**Table of Contents for 1015 E. 12<sup>th</sup> Street Tree Permit**  
**Heritage Tree Variance Package**

**SUBJECT:** 1015 E. 12<sup>th</sup> Street Heritage Tree Removal

**REQUEST:** The applicant is requesting to remove a heritage tree with a stem greater than 30 inches as allowed under LDC 25-8-643

Exhibit 2 *CC*  
*8*

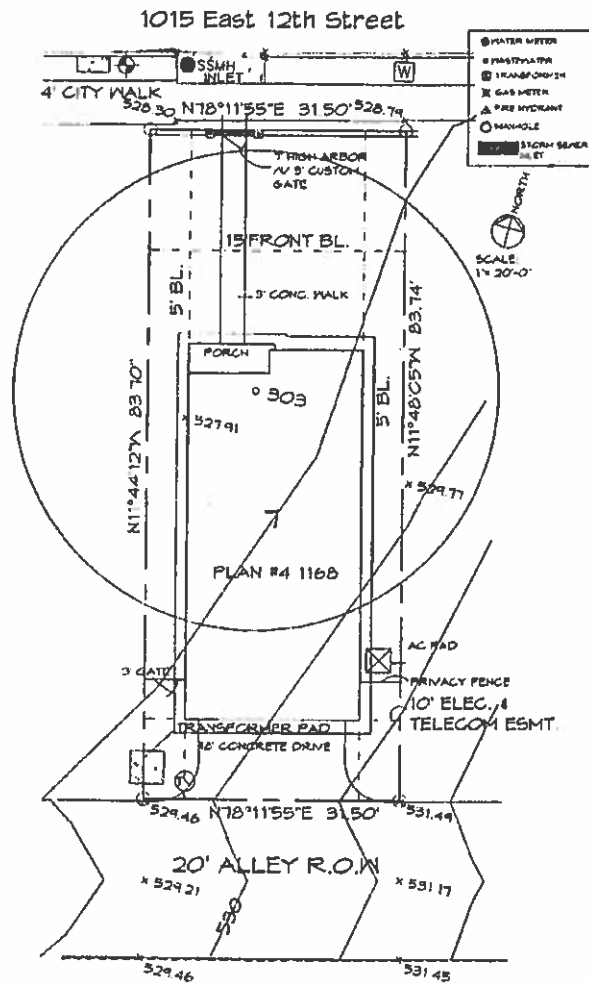
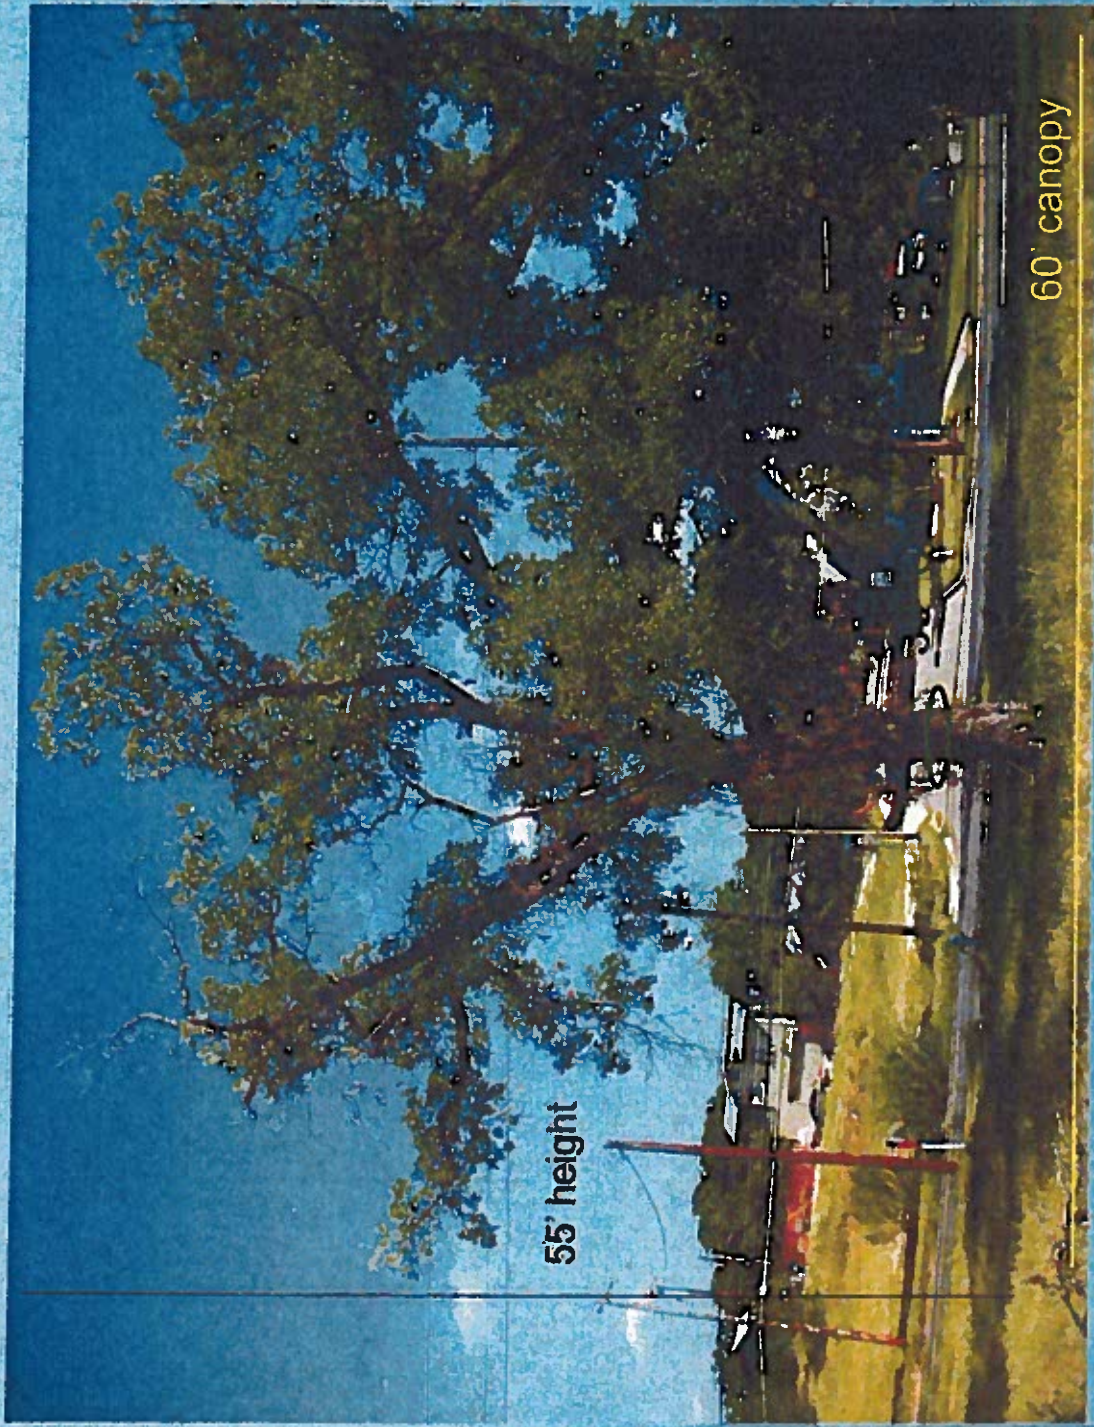
The subject property is number seven of 10 lots located at 1015 E. 12<sup>th</sup> street (Exhibit 1). The zoning for the lot is CS-MU-NCCD-NP. The lot size is 31.5' (width) x 83.70' (depth) and the tree location is in the center of the lot (Exhibit 2). The desired use is a single-family residence. The property is located in the Waller Creek Watershed and is subject to urban watershed regulations.

Exhibit 6

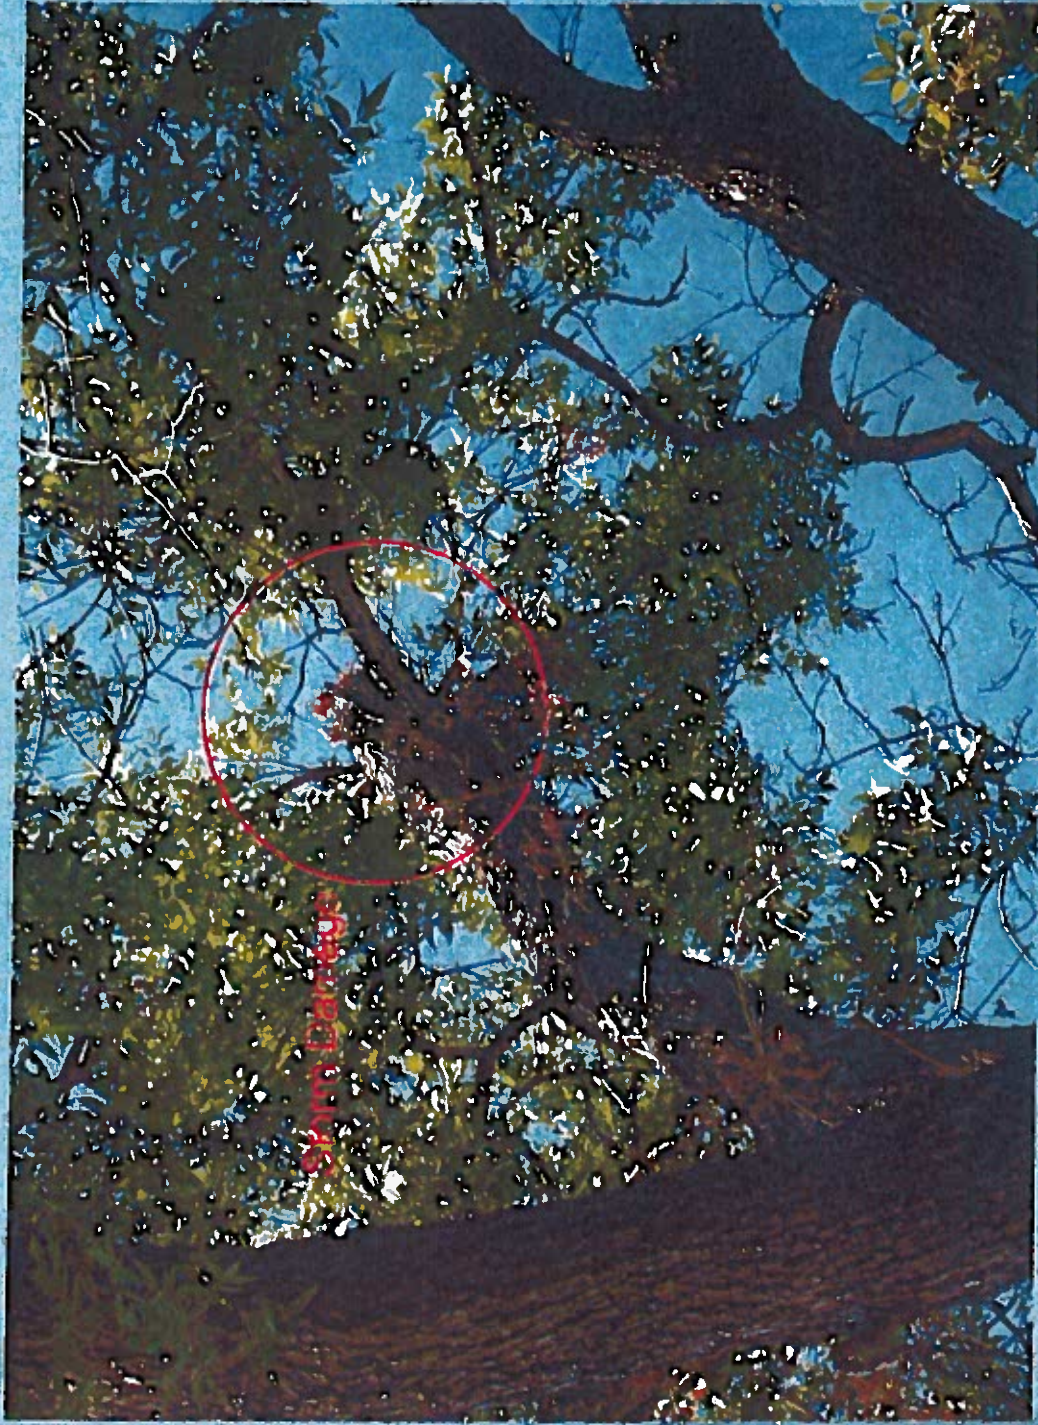
The canopy architecture displays minor asymmetry. Storm damage and/or dieback in the canopy are evident in most branches (Exhibit 4). Minor cavities and decay are present in several stems (Exhibit 5). Reaction wood, likely compensating for solid wood loss, has occurred in one of the scaffolding branches (Exhibit 6). One of the main leaders has been broken, likely resulting from storm damage (Exhibit 7).

## Site Plan

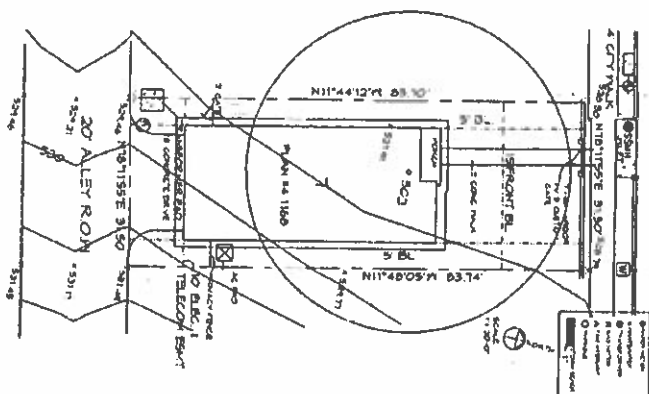
A request has been submitted by Jon Smiley, President, ion Constructors and Austin Stowell, Development Partner, Butler Family Interests to remove a pecan tree, approximately 30" in size from the center of the lot located at 1015 E 12<sup>th</sup> Street. Please see attached site plan and survey for reference.

The presence of this particular tree prevents reasonable use and development of this lot due to the size of the lots and size of the critical root zone (CRZ). The size of the lot and the required setbacks leave us with little option other than removal. We have exhausted efforts to create a reasonable alternative design. The side setbacks provide us with only 21.5' of width in which to build. The trees central location in this parcel prevents a lateral design change. In addition, the front setback of 15' and rear setback of 10' further restrict our options and force us to remove the tree in order to maintain reasonable use of this particular parcel. There is not an alternative orientation of the structure that would allow us to both build on the lot and retain the tree. We are therefore seeking a variance for it's removal. We have met with both Keith Mars and Michael Embesi of the City of Austin Arborist Program and have retained staff recommendation to remove the tree.
